D/DRC Case

1311 Summerville Avenue

DESIGN/DEVELOPMENT REVIEW COMMISSION
DESIGN REVIEW DISTRICT
HISTORIC AGENDA
EVALUATION SHEET
Case # 10

NATURE OF REQUEST: Request Certificate of Design Approval for an addition

FIRST FLOOR PLAN

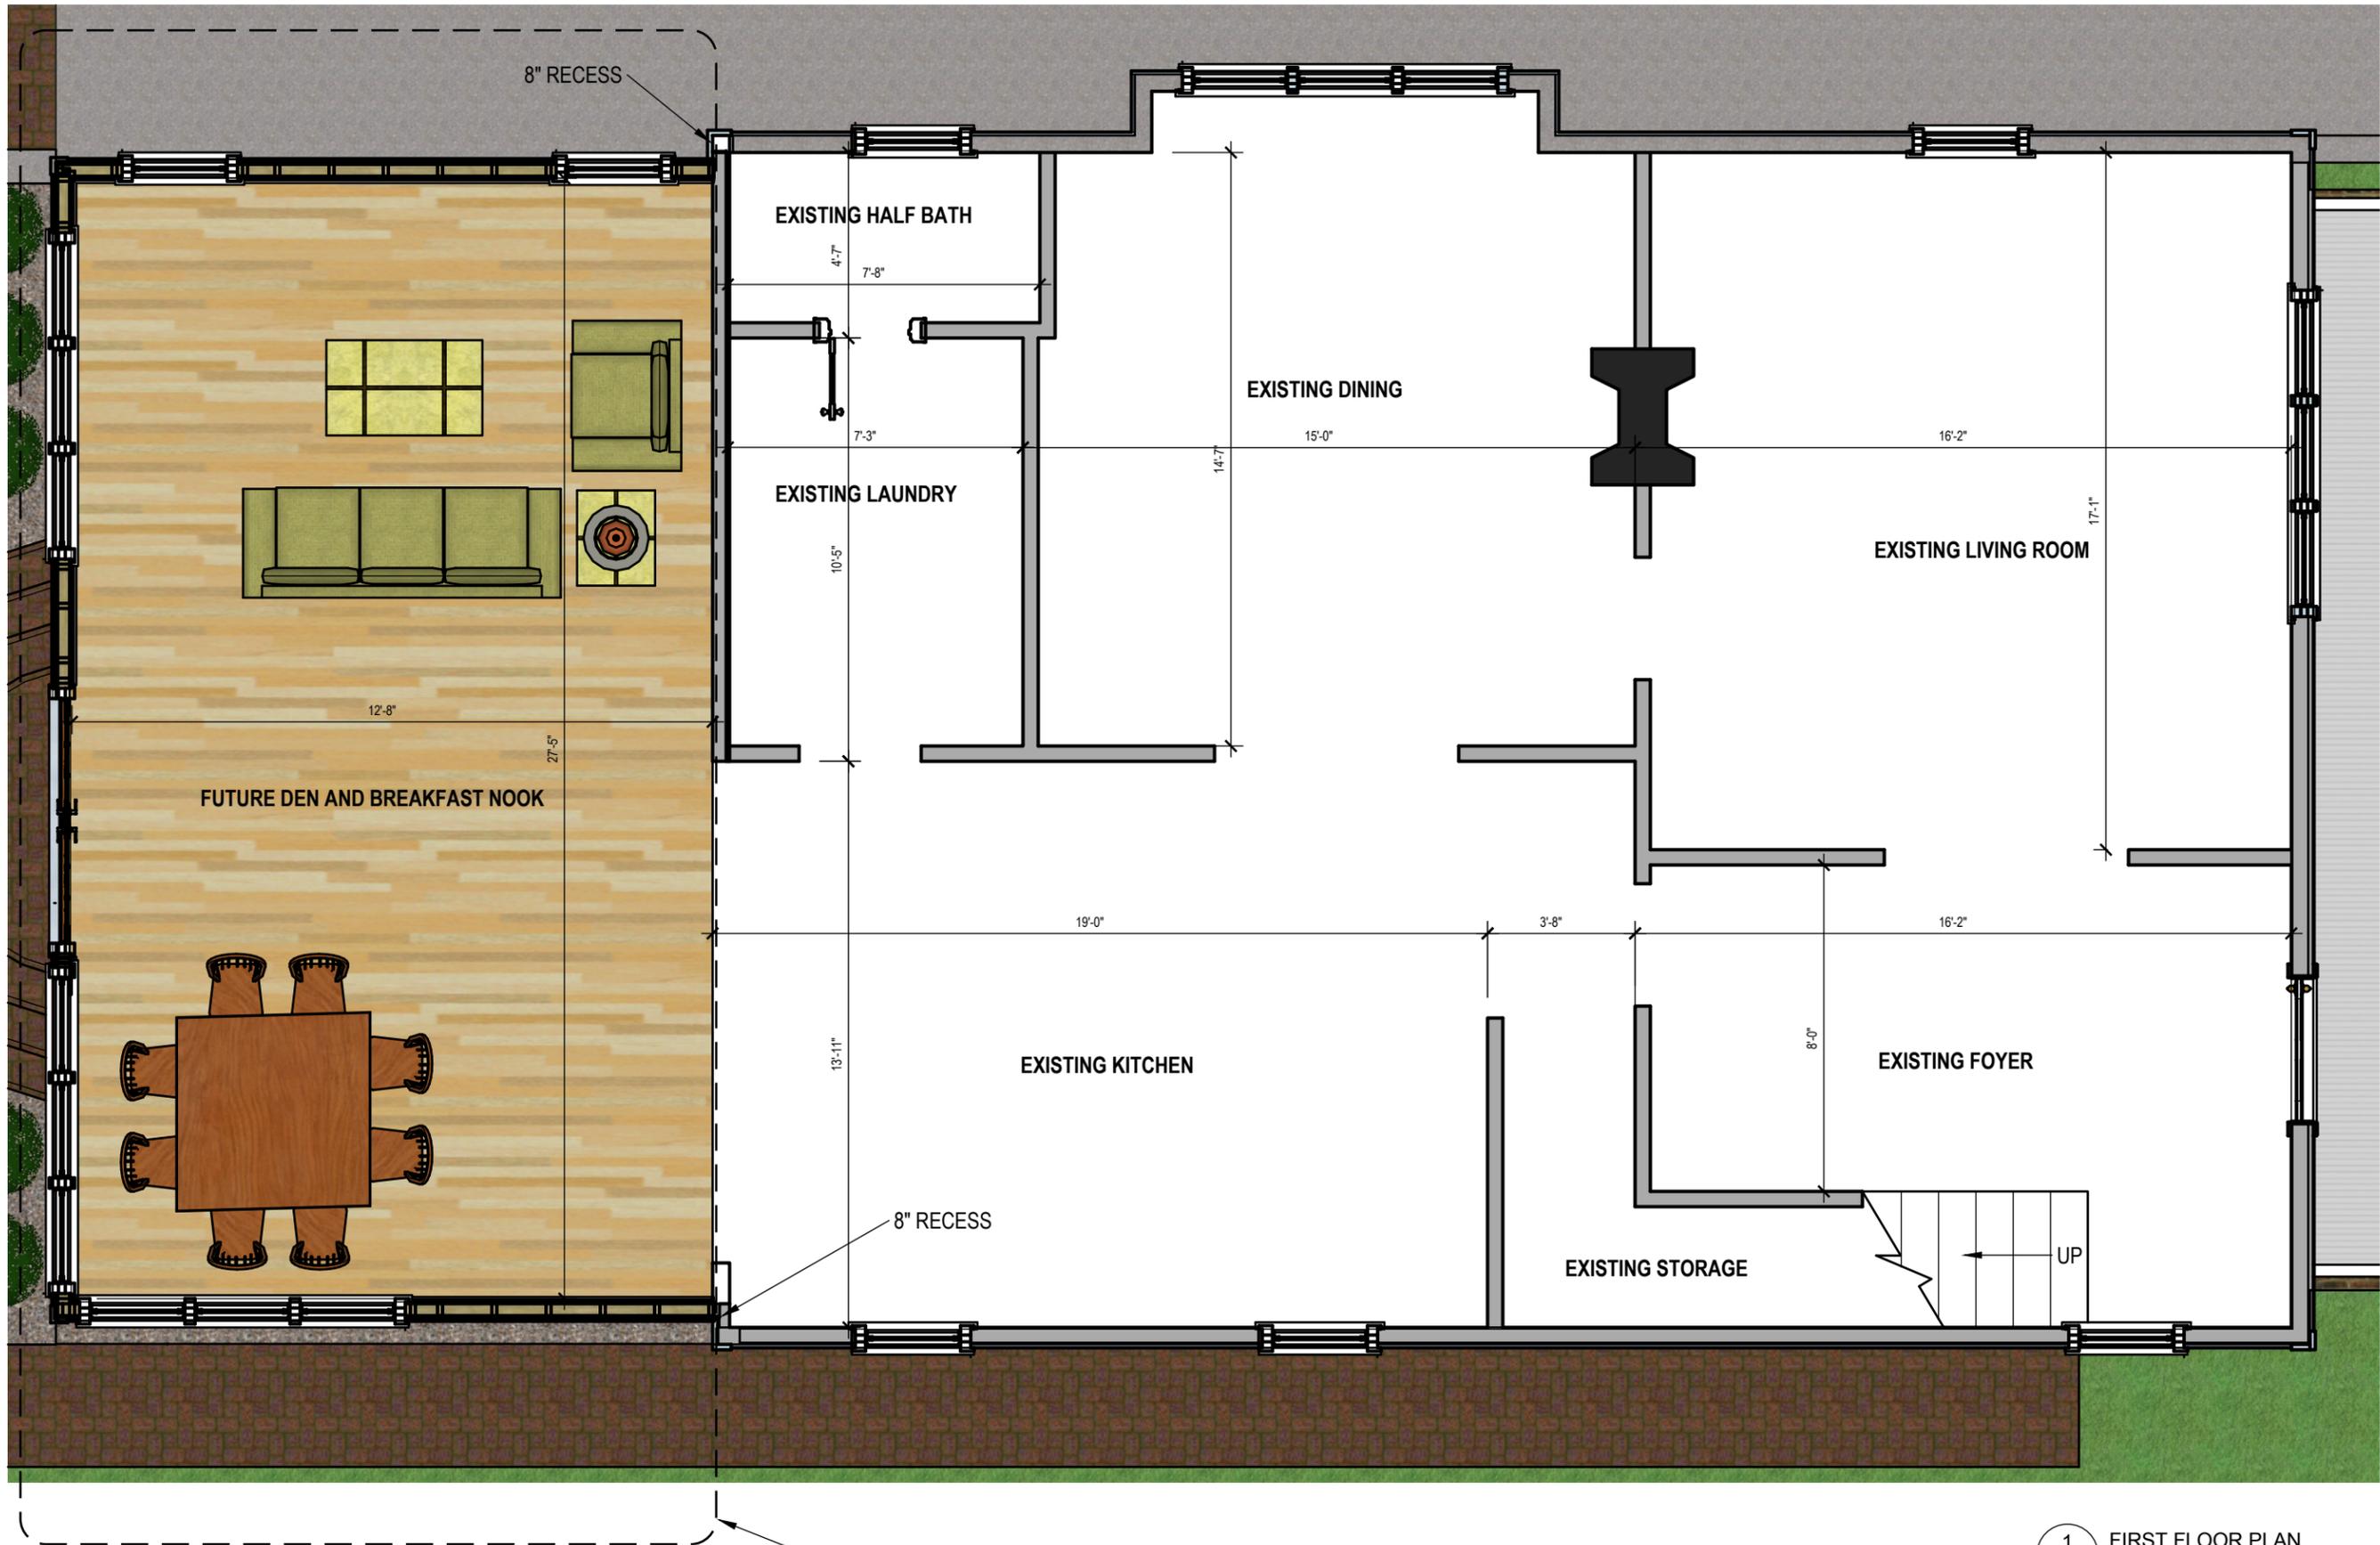
Staff is unsure as to the actual size of the addition. It is shown as 13' in length but dimensions from the interior of the house show both 13' and 16' for the same area. Additionally, since the cornerboard has shifted to the right in this proposal, the new addition could look smaller on the plans than it potentially is.

ARCHITECT.
RENDERING

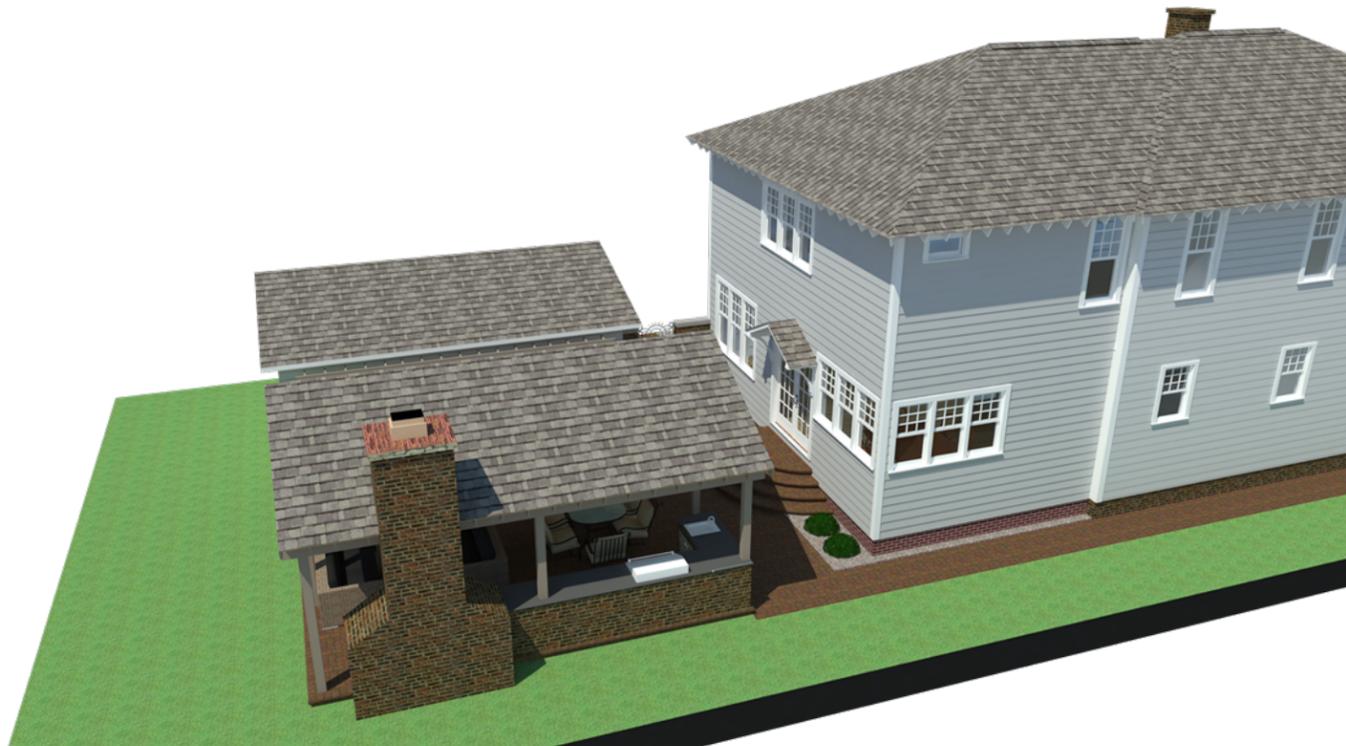
Please note that the window configuration shown on the renderings is incorrect; the windows on the home have a 4/1 or 5/1 pane configuration (or if sized differently, a proportionally appropriate version). Also, the two smaller windows shown on the left elevation of the extant home are not reflective of the actual size of the existing windows, which are just slightly smaller than the other full-size windows on the house.

A 2.1
BUILDING
ELEVATIONS

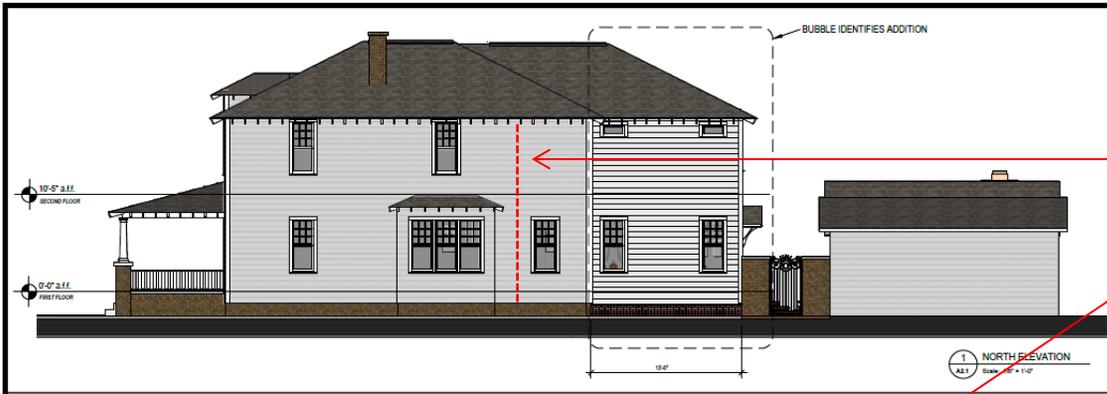
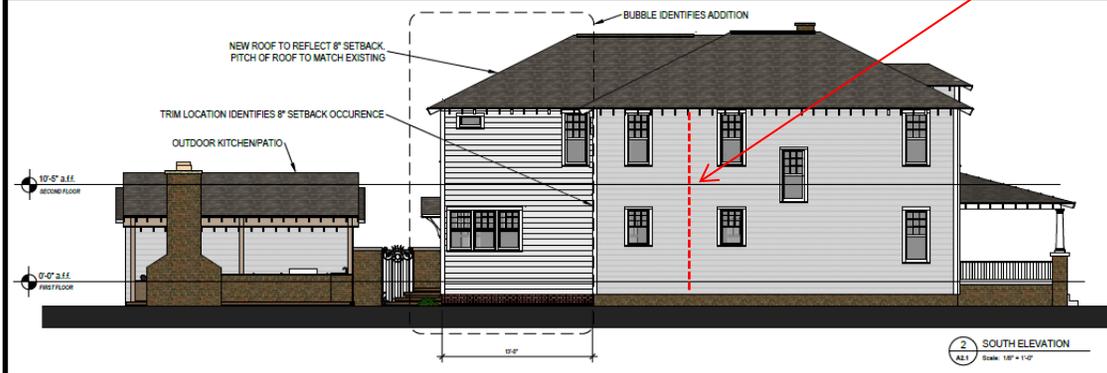
There is what appears to be a one-story addition on the back of the home; a few feet of siding, a window, and roofing is visible and its details match those of the home. The proposed new addition incorporates this earlier one, pulling it up to the full two-story height, shifting the existing cornerboard over to the new edge which then recesses about 8" where additional square footage begins. The 8" recession is intended to distinguish the original footprint from the later construction. The cornerboard is shifted in an effort to indicate where the older one-story addition stops and the new construction begins; staff is appreciative of the attempt but it ends up changing the understanding of the original footprint and proportions of the home. Staff would recommend keeping the original cornerboard in place and recessing back from this point while perhaps finding other gestures to reference the one-story addition. Staff has drawn in the approximate location of the extant cornerboard on a rendering in the packet for clarification. This is actually the point at which the addition should step in 8-12".

Approximate locations of
cornerboards currently
